**ADDENDUM NO. [1]**

**Date: September 13, 2019**

**RE: SCHOOL DISTRICT OF LA CROSSE  
7 RIVERS CHARTER SCHOOL  
225 5<sup>TH</sup> AVE SOUTH  
LA CROSSE, WI 54601  
HSR 19003**

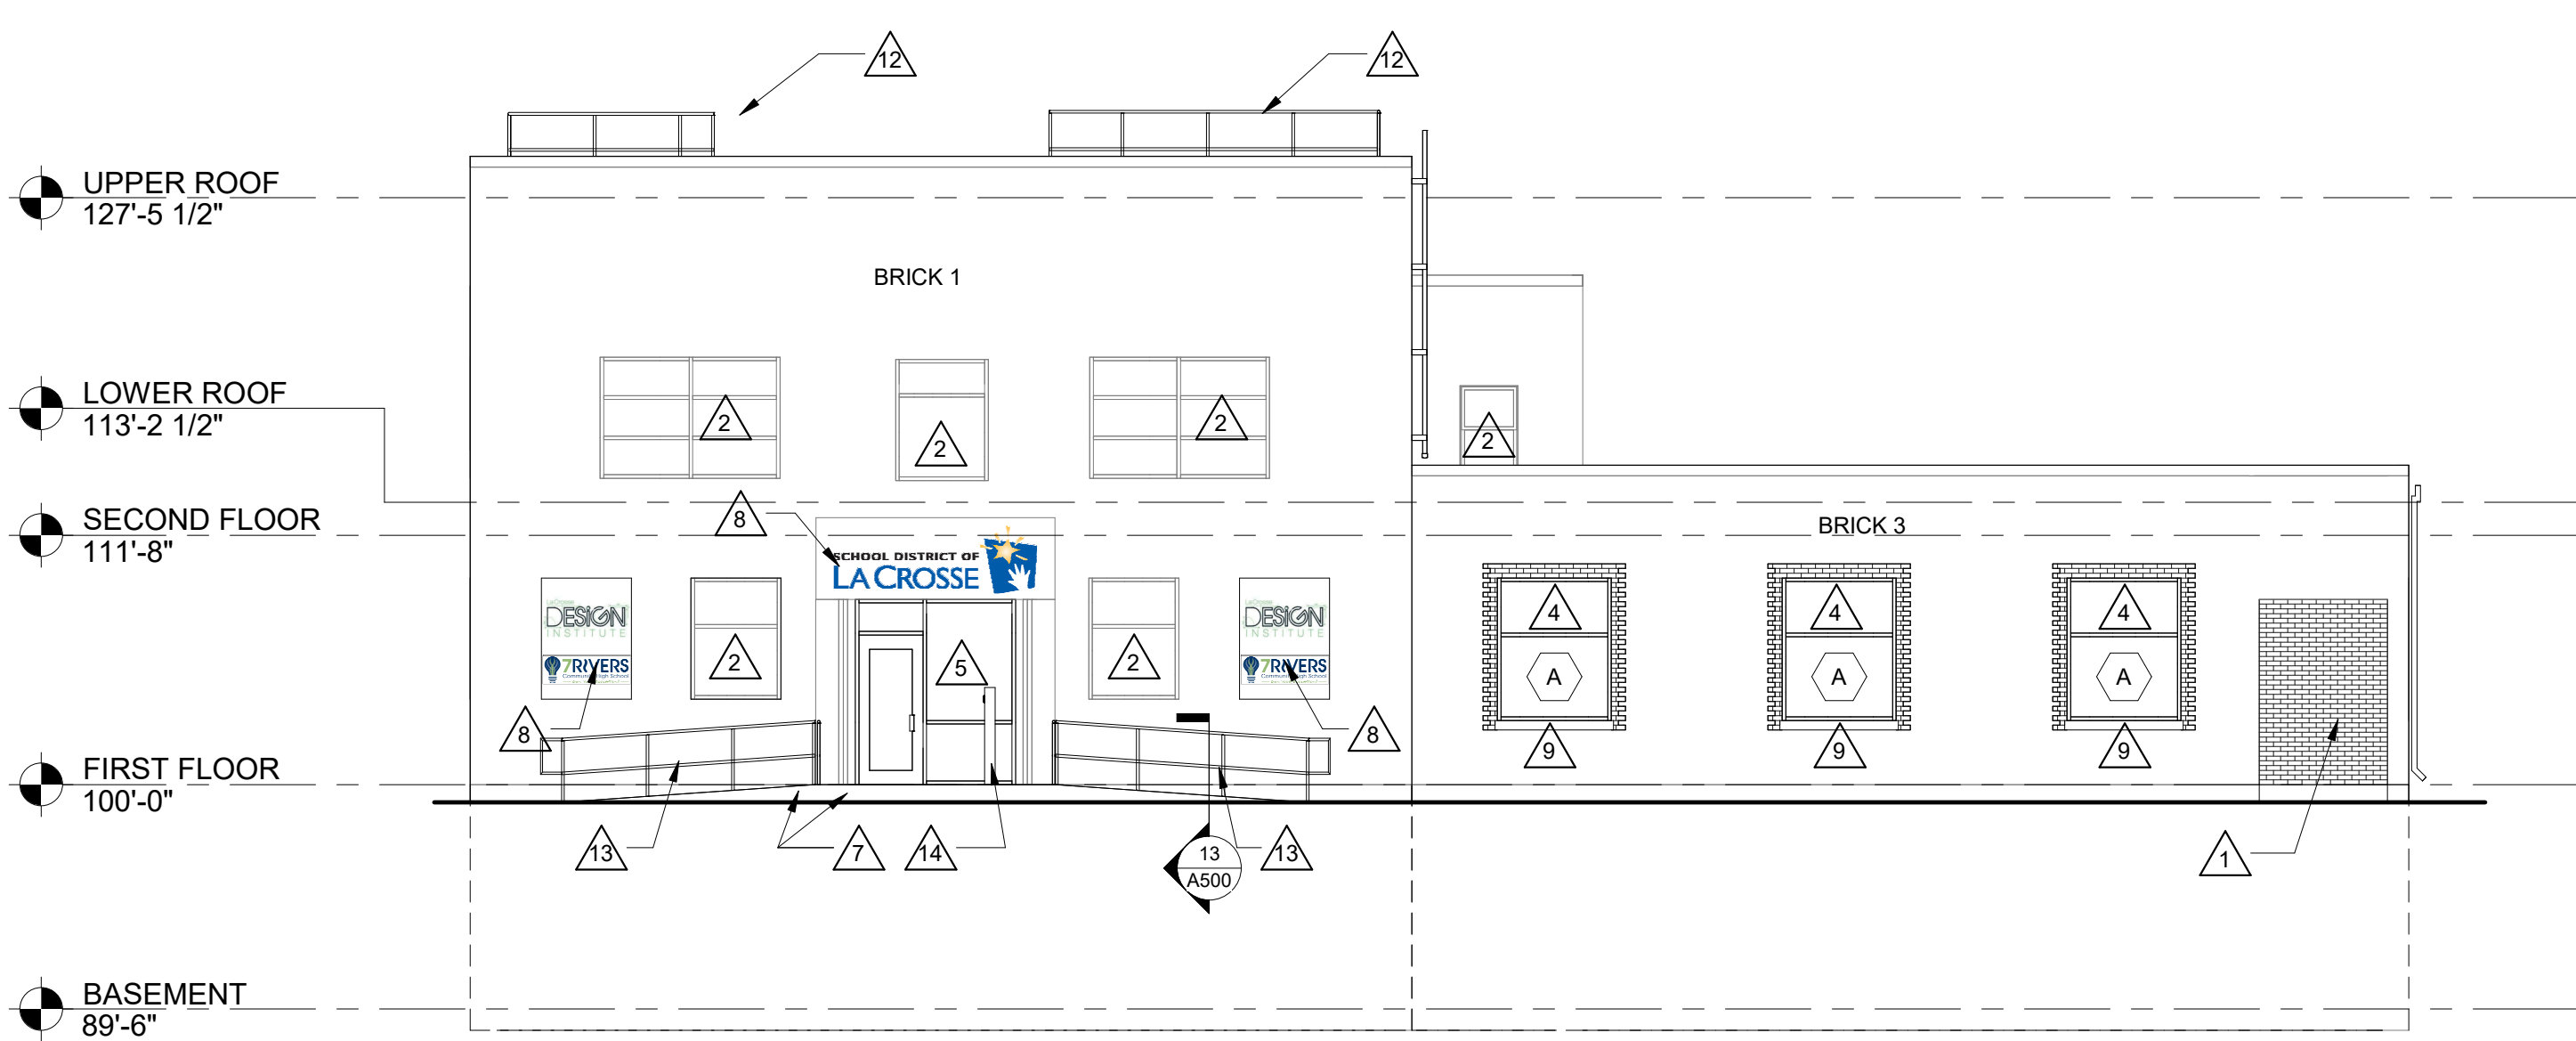
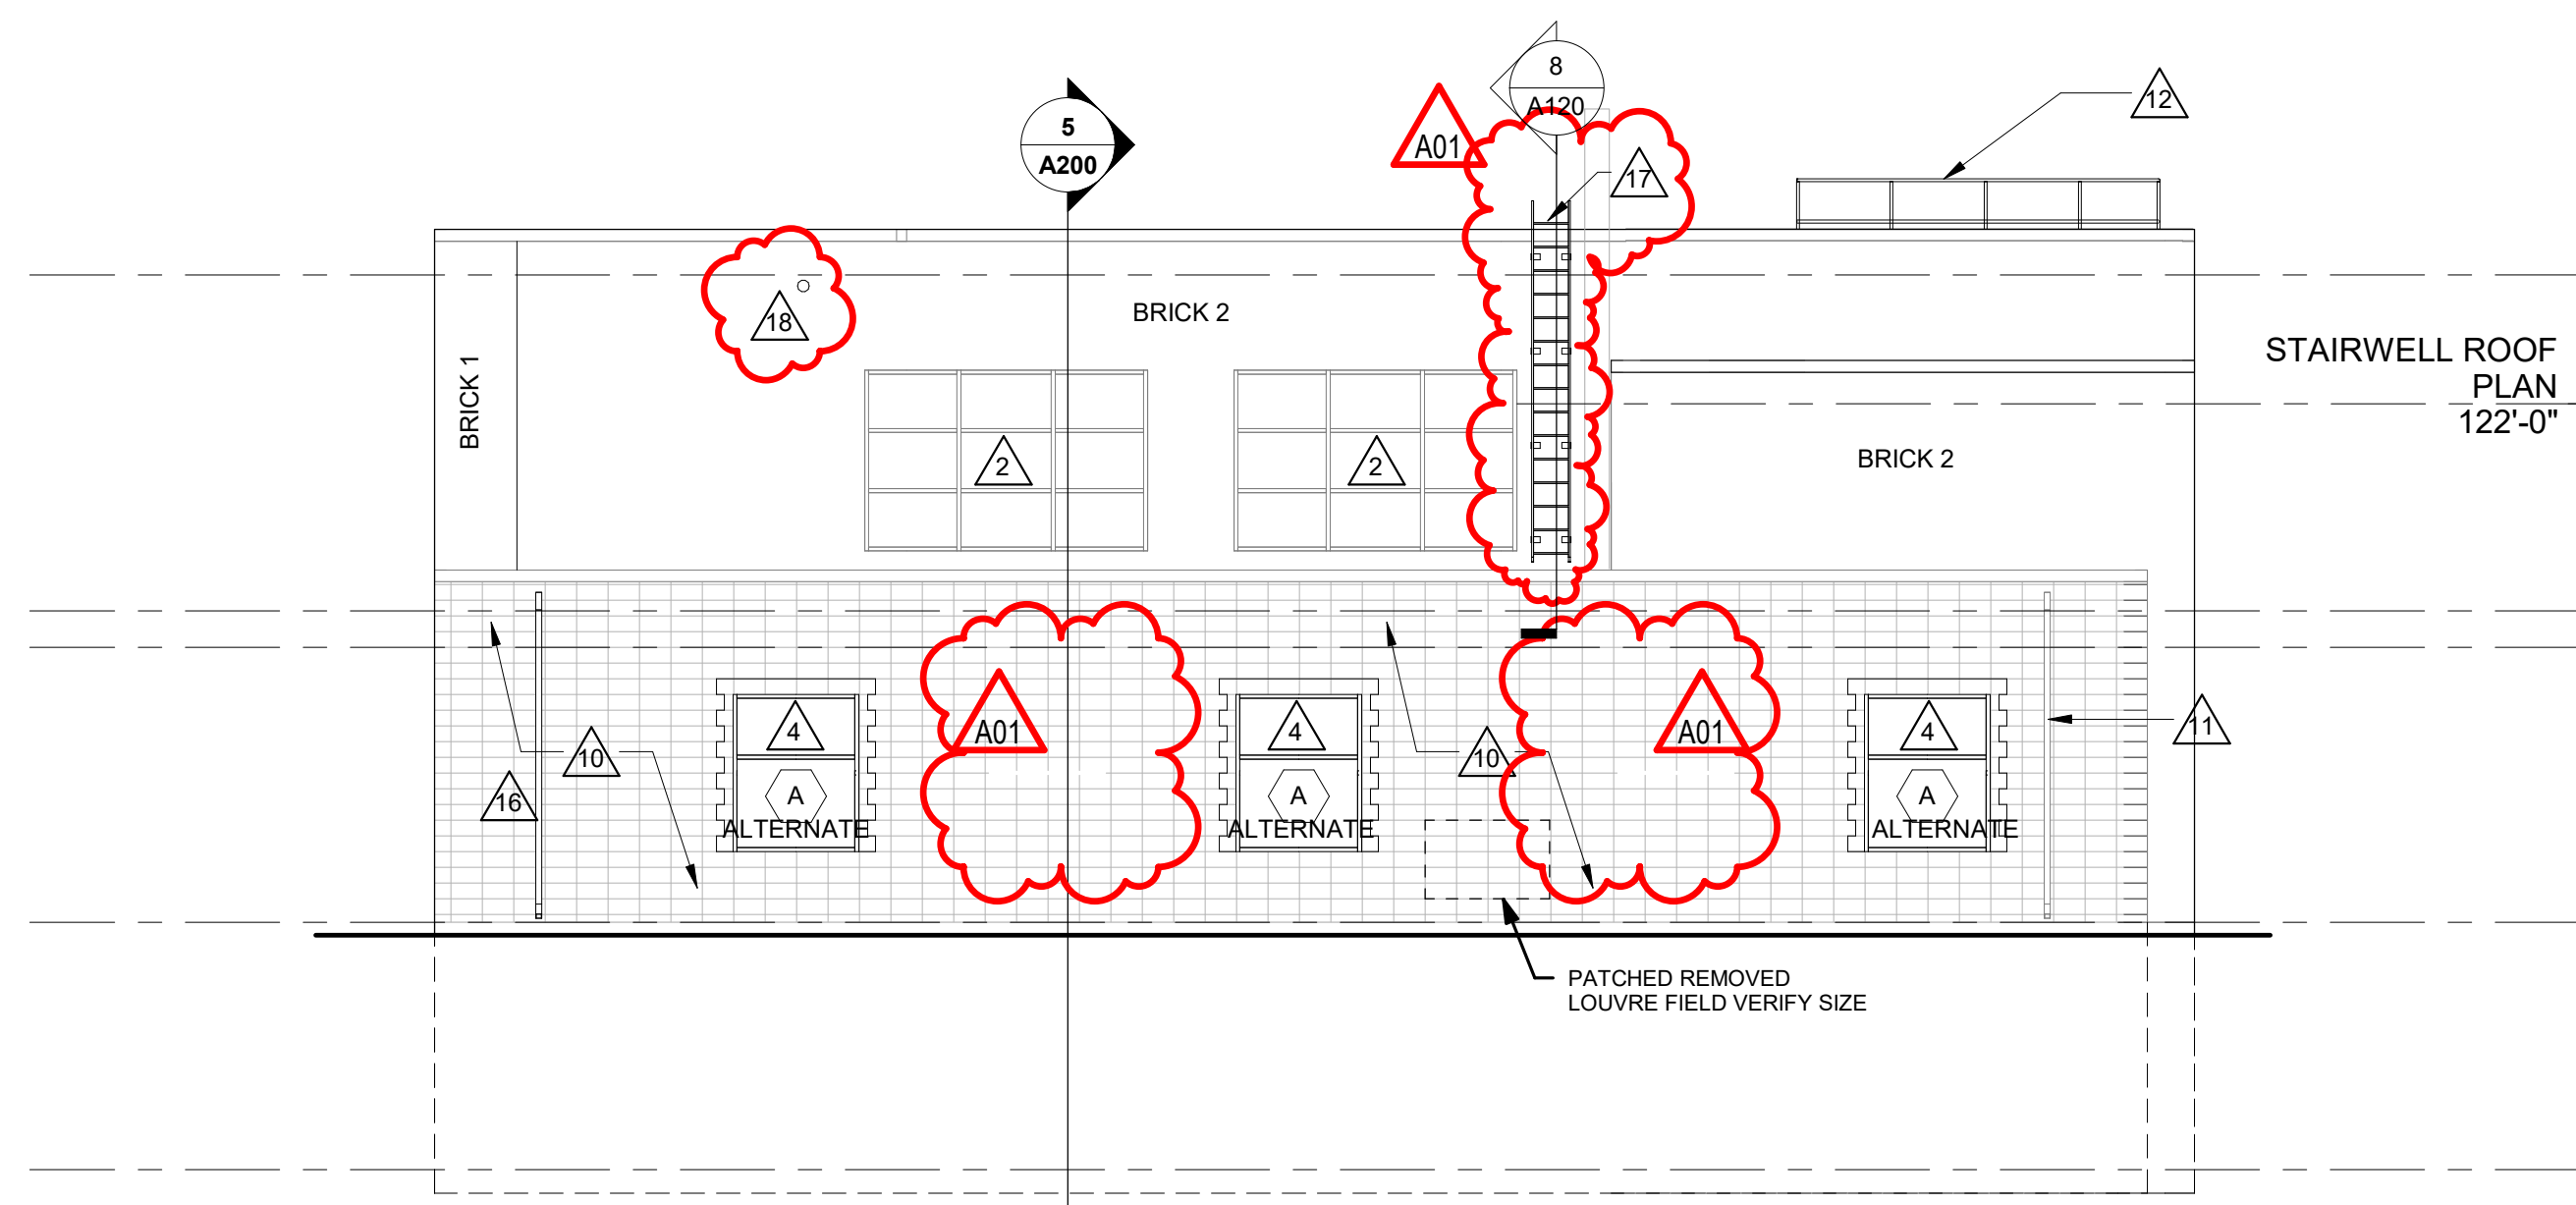
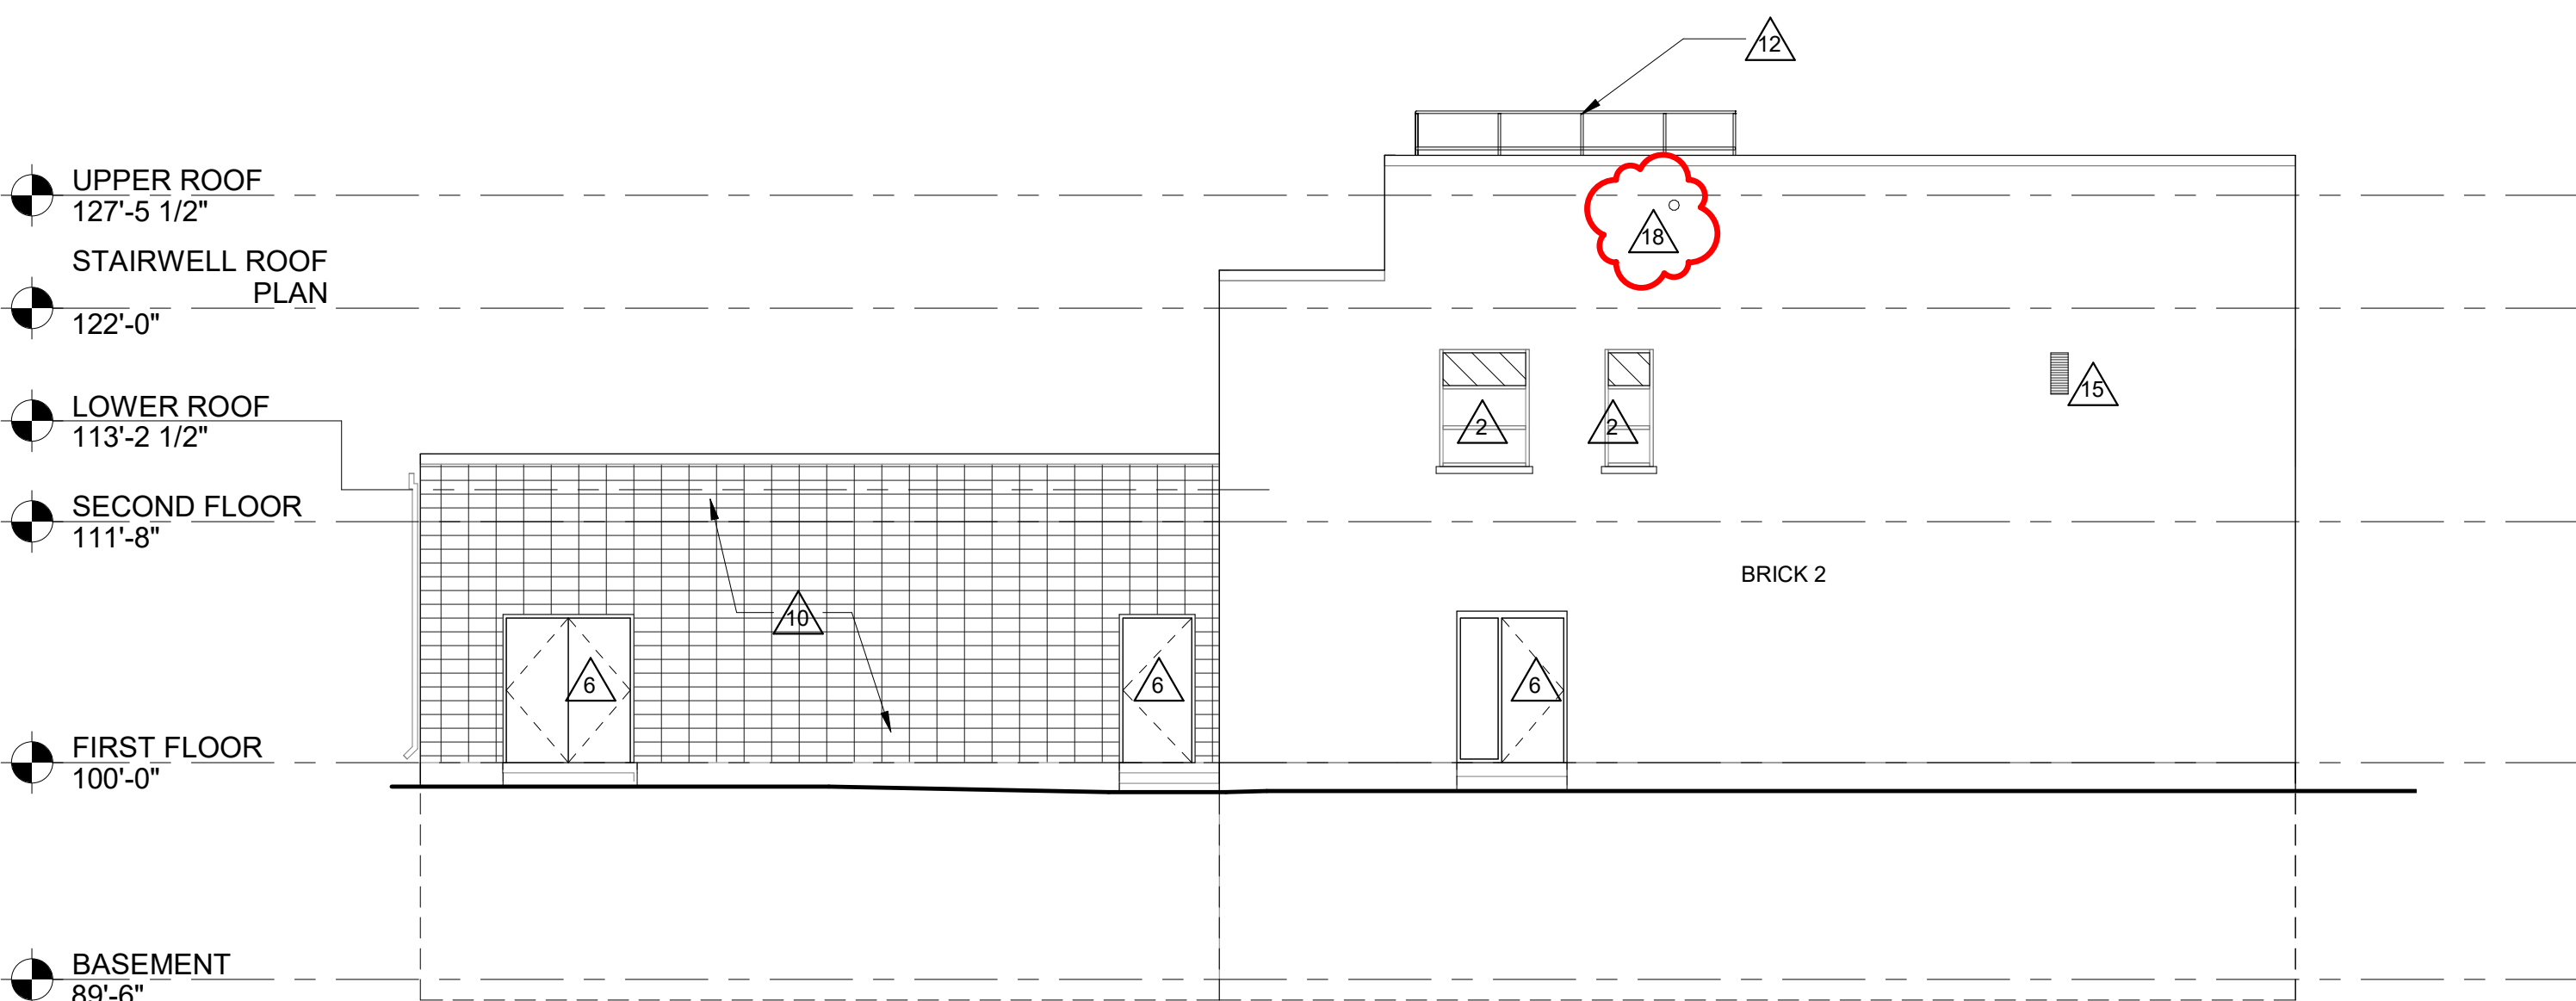
25. Sheet A200 EXTERIOR ELEVATIONS AND BUILDING SECTIONS 30 x 42 attached hereto

- a. Revisions clouded on Drawing.
- b. Roof ladder added to access south roof.
- c. Over flow drain lambs tongues located.
